## UPPER GROUND FLOOR

Prior to the sale of the property to a single purchaser, various conditions to the current Listed Building Consent, LPA Ref: 2016/6022/L, were discharged and the works undertaken.

In addition to the overall new proposals now sought for a single family dwelling, specific approval is sought for items under the current approval LPA Ref: 2016/6022/L, which required specific conditional discharge:

Extract from approved drawing 9000-DRG-00KH-DE005 C3

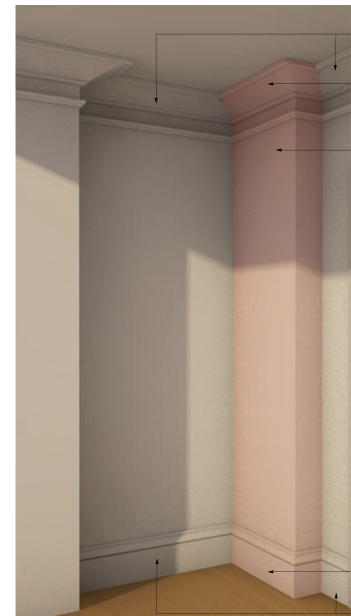
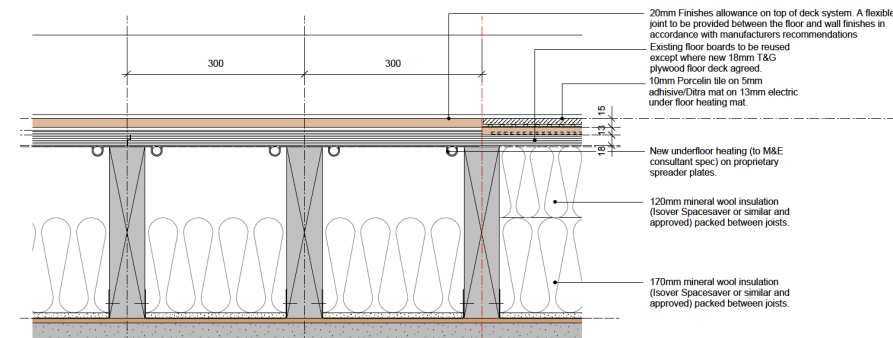
The opportunity has been taken to review and rationalise service routes through the building to ensure the minimum impact on the existing fabric, or where unavoidable as disguised as possible

The current approval incorporates the installation of wet underfloor heating to the large adjoining rooms (proposed living room and study). The location of the pipework, immediately below the existing floorboards, necessitates notching of the floor joists at the end of every loop.

It is now proposed to remove the existing boards and set these aside for reuse elsewhere in the building where flooring is damaged or missing, replacing the boards with a propriety system that incorporates the heating coils within a base board that sits directly over the joists.

DRAWING  
Kidderpore Hall  
Level 01 Proposed GA Plan

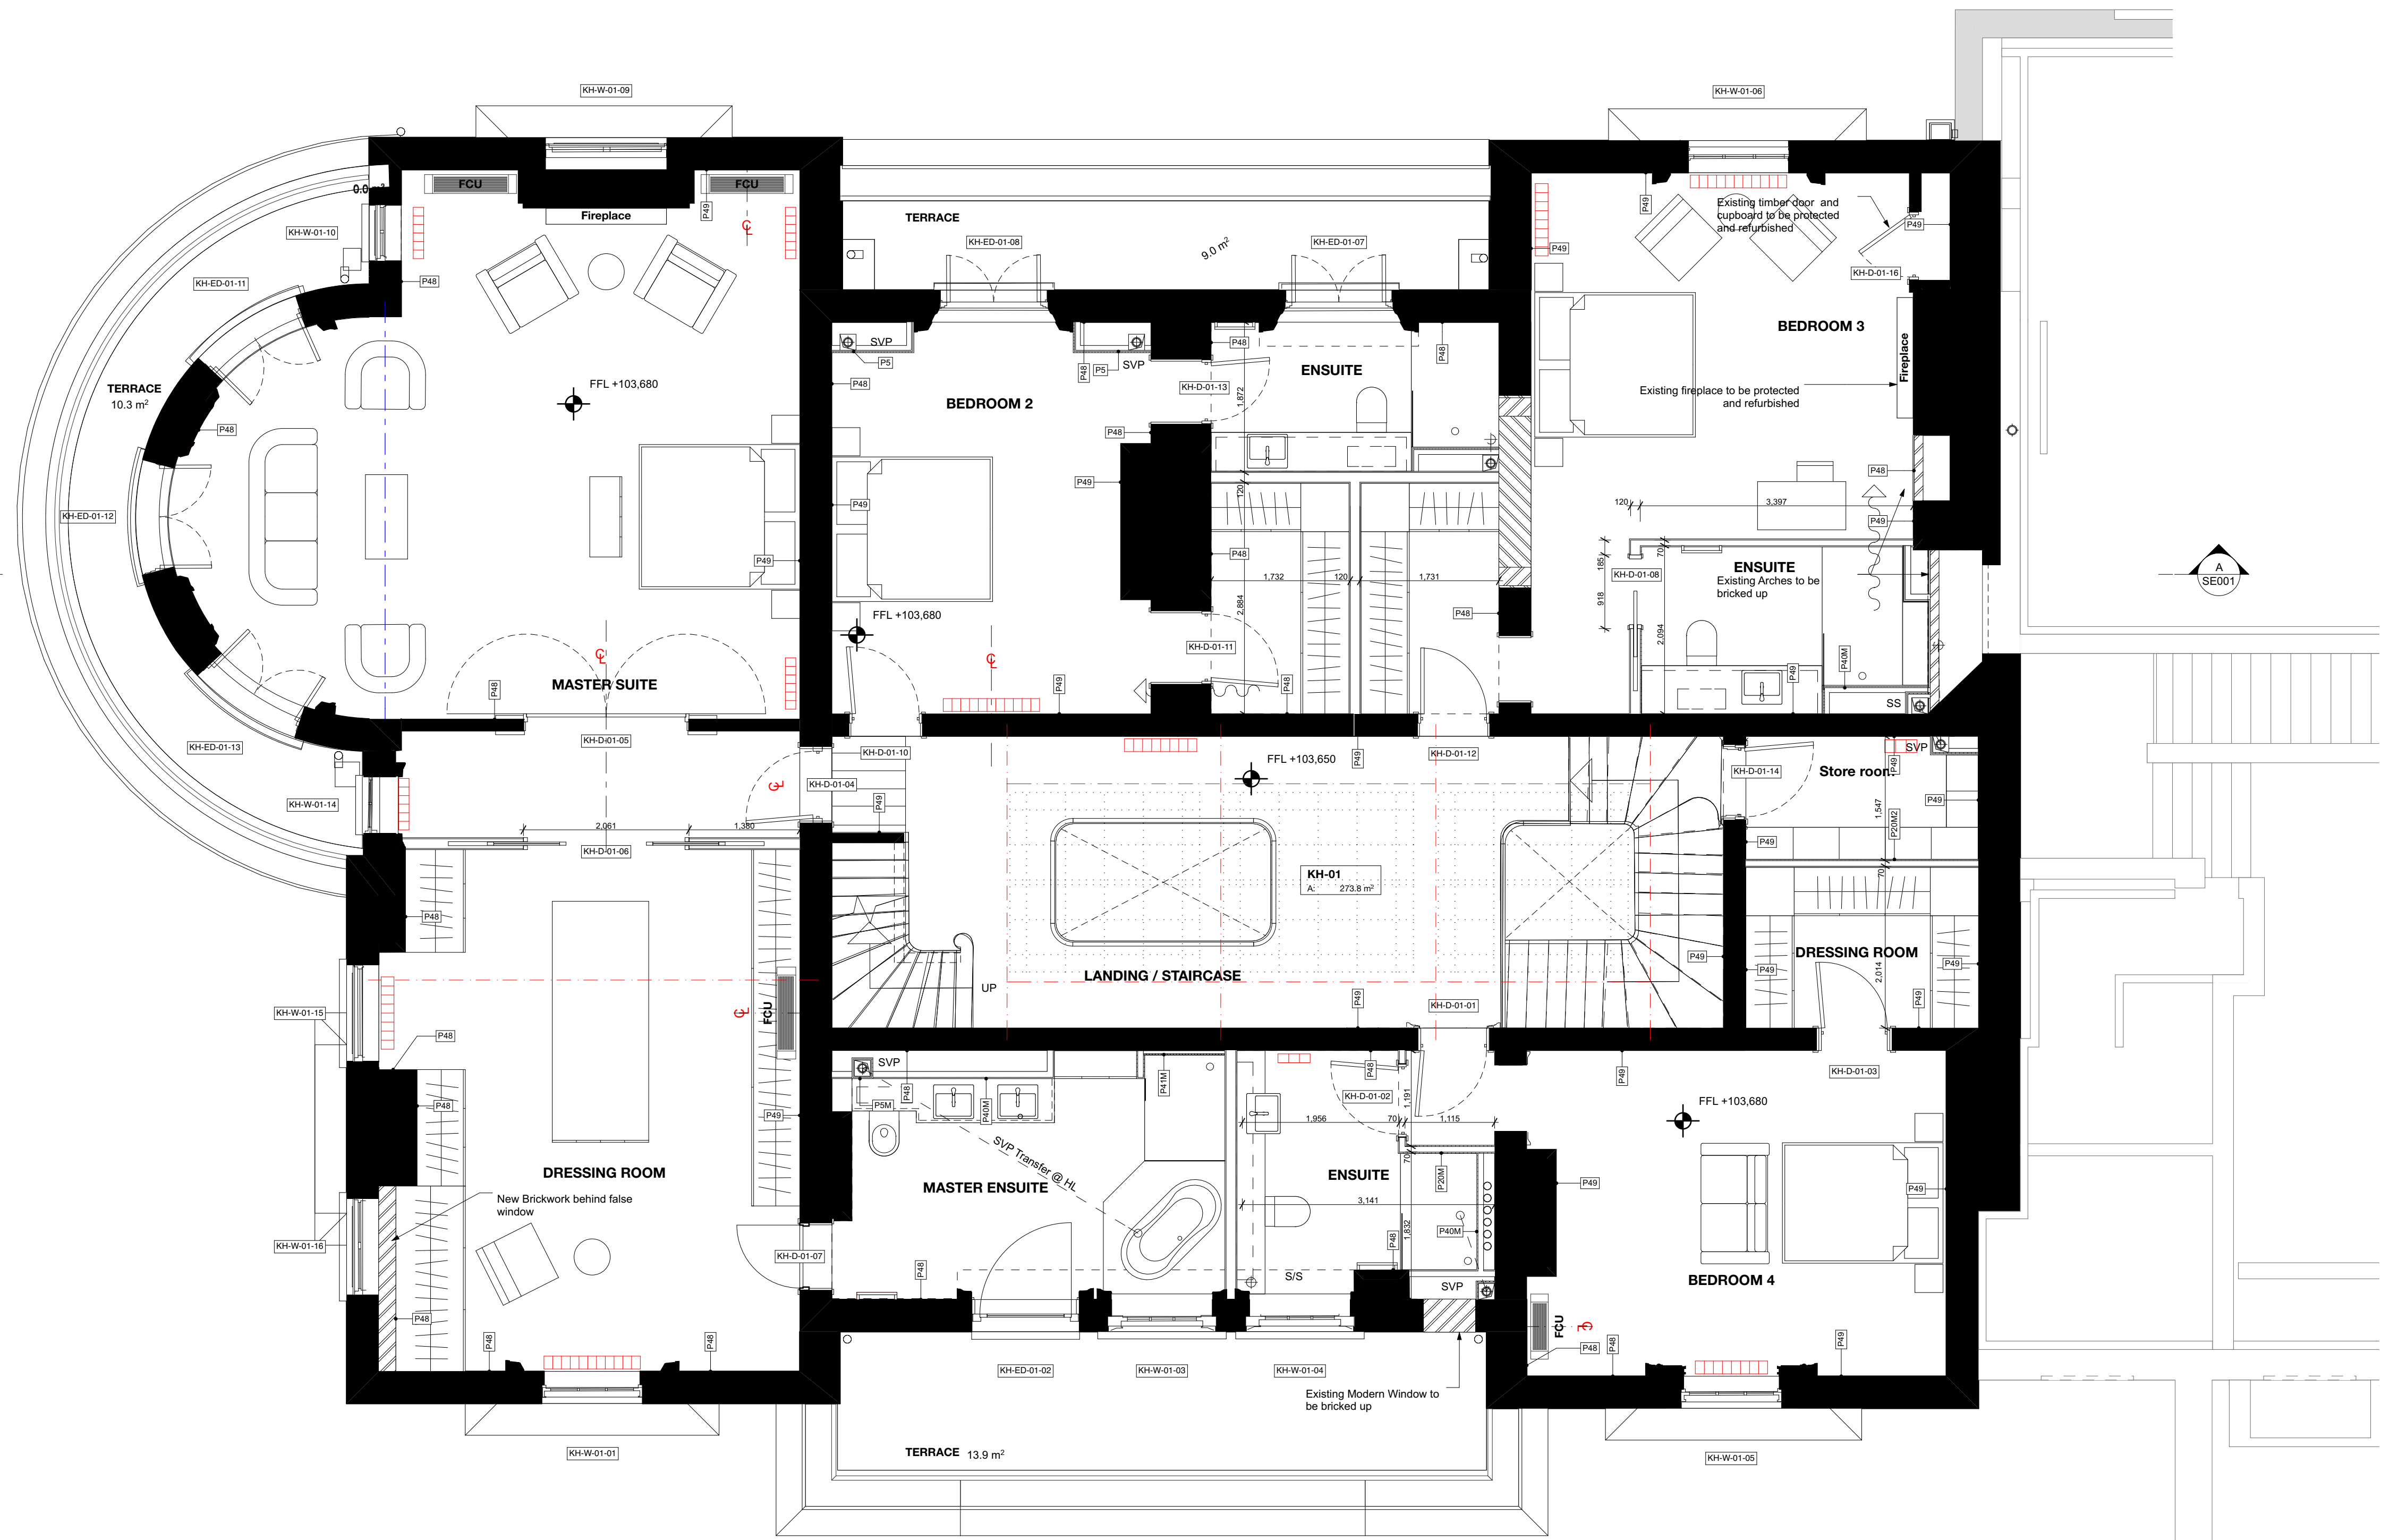
With the change to a single dwelling, reception rooms at this level need to be amended to bedrooms and associated en-suite and dressing rooms.

Some approved structural work, forming new openings etc has already been completed, but will now need to be reinstated (proposed Bedroom 3).

The opportunity has again been taken to review and rationalise service routes through the building to ensure minimum impact on the existing fabric.

As with the Upper Ground Floor, the current approval incorporates the installation of wet underfloor heating to the large western rooms (proposed Master Bedroom and Dressing Room). Similarly to the upper ground floor, it is now proposed to undertake this with a propriety system that incorporates the heating coils within a baseboard that sits directly over the joists. The existing floorboards will be used elsewhere to repair or replace defective flooring. Electric underfloor heating will be utilised in remaining rooms, together with radiators.

DRAWING  
 Kidderpore Hall  
 Level 02 Proposed GA Plan

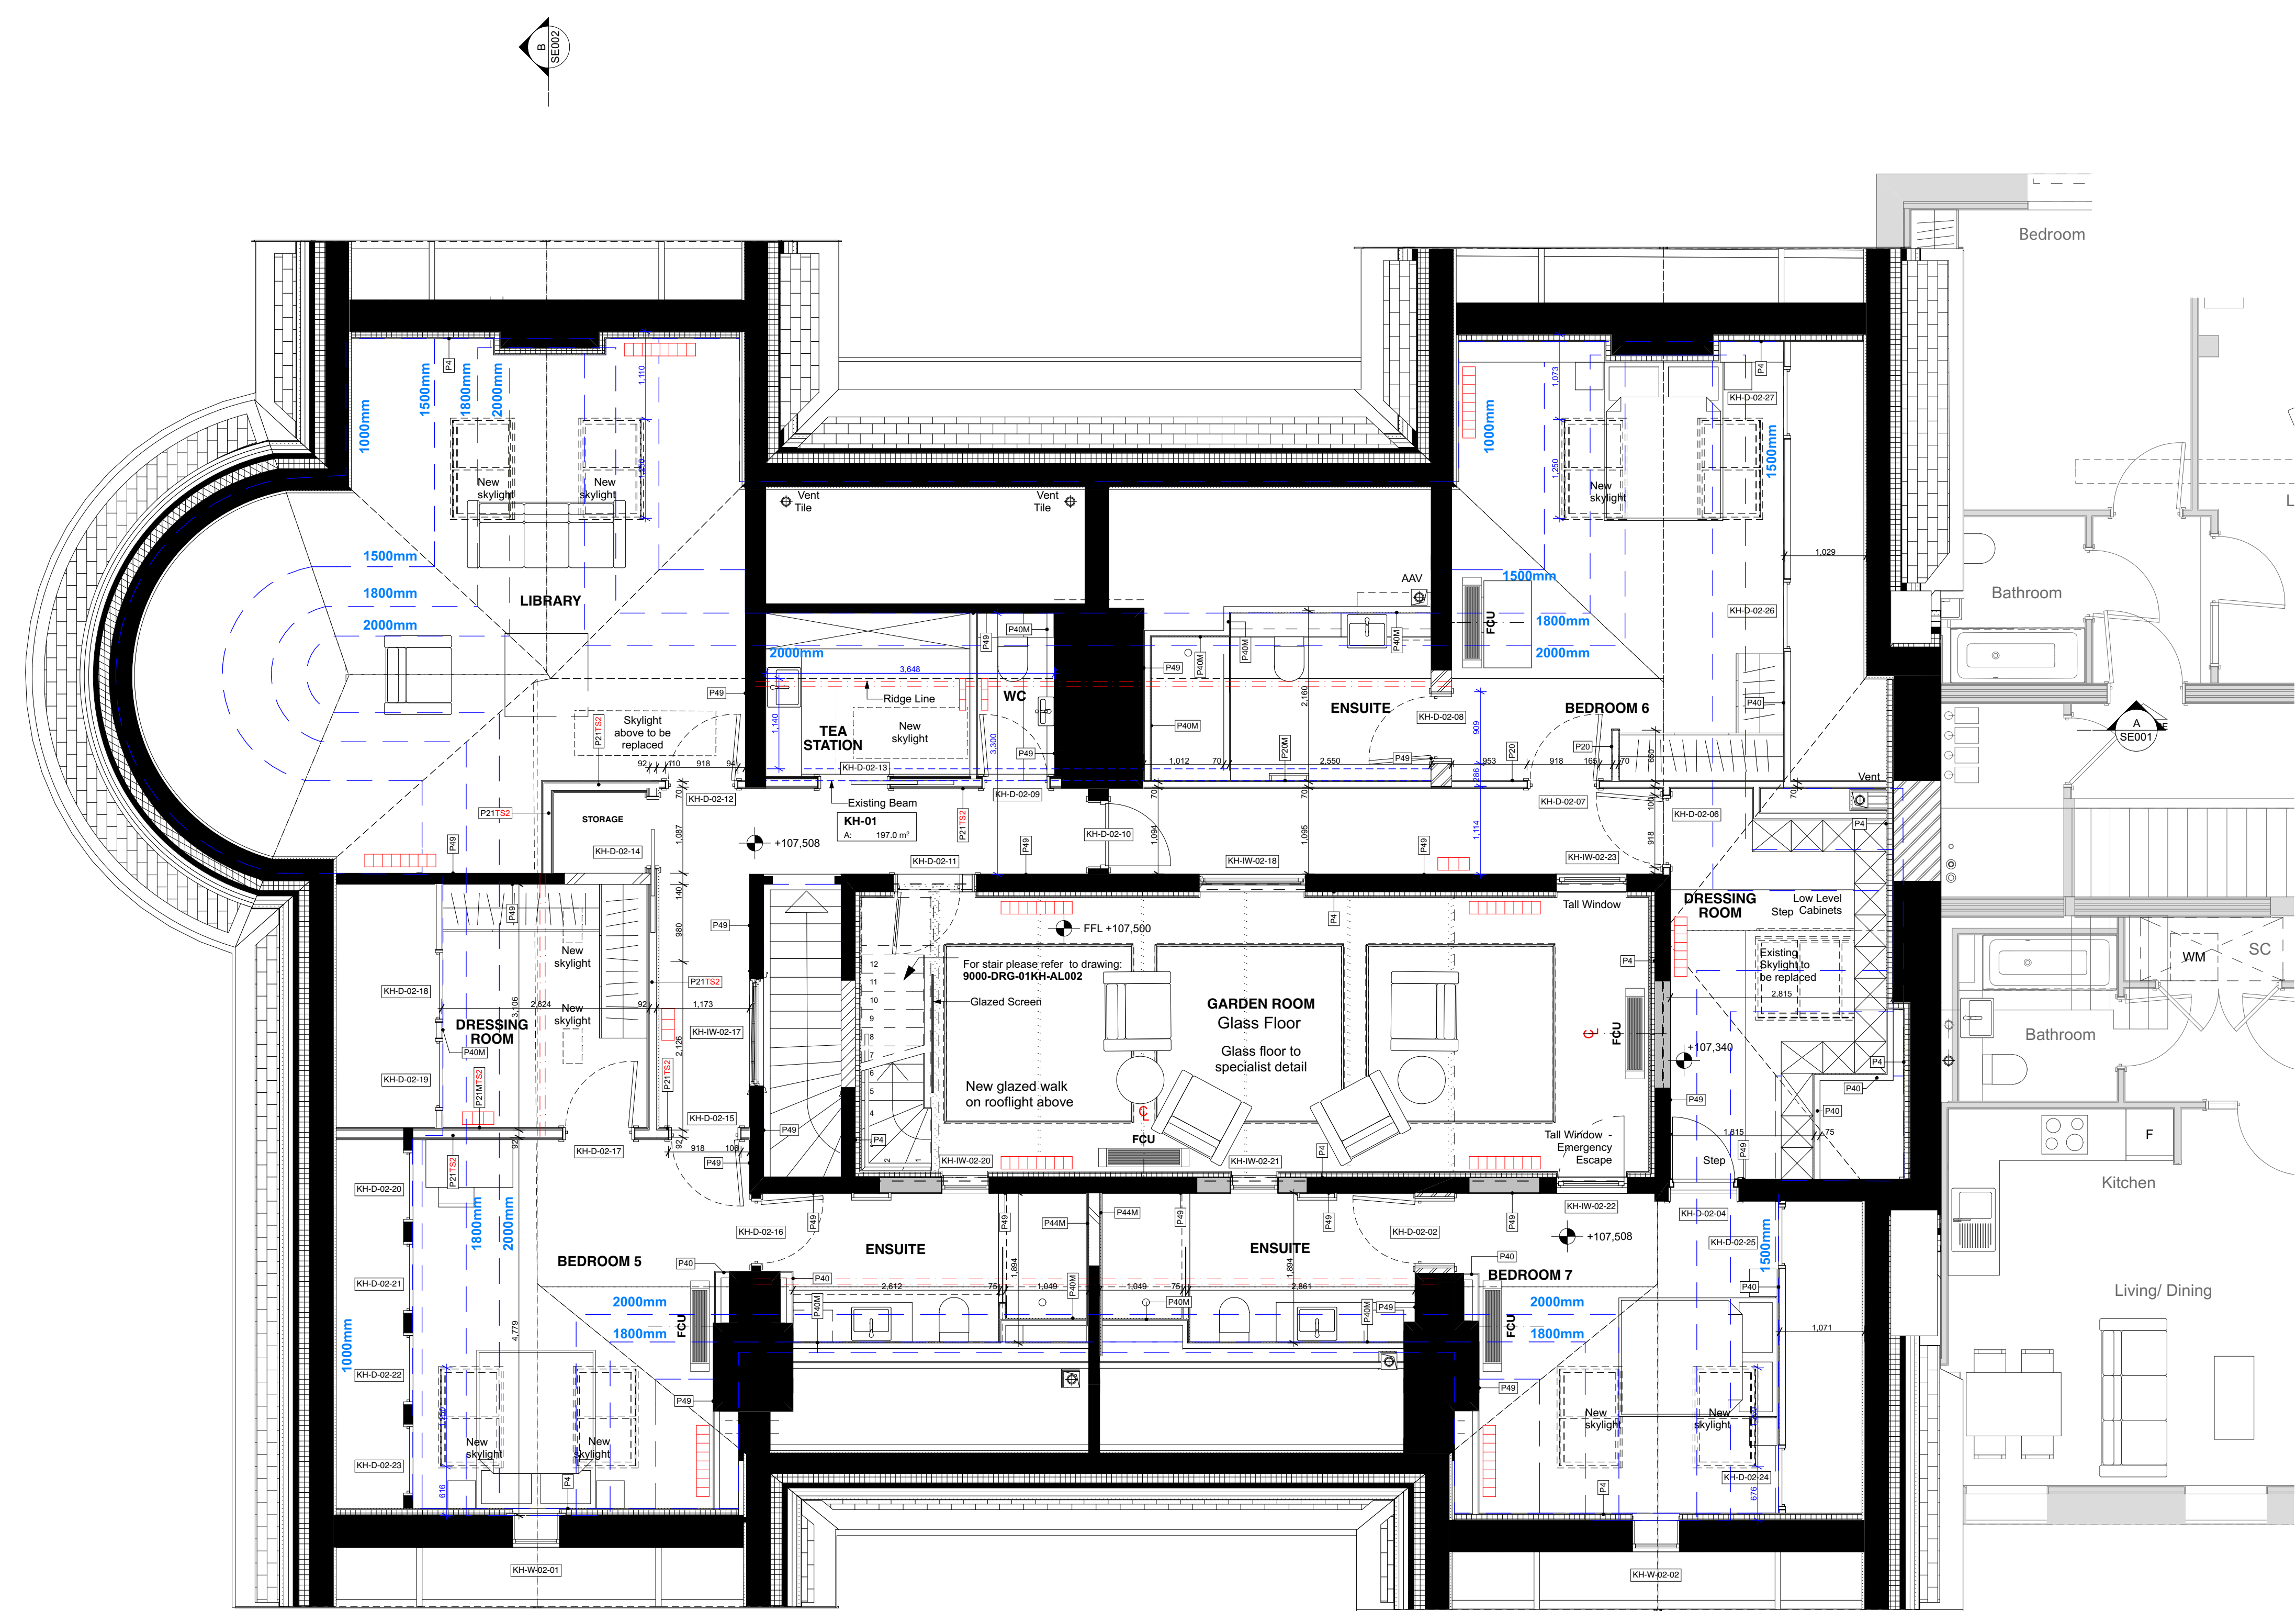
The use of the rooms remains broadly as currently approved, providing bedrooms and associated facilities, whilst also maintaining the feature Garden Room.

At this level it is proposed to utilise electric underfloor heating together with radiators.

Cooling has been introduced at this level with Fan Coil Units in joinery casings to all bedrooms and the Garden Room.
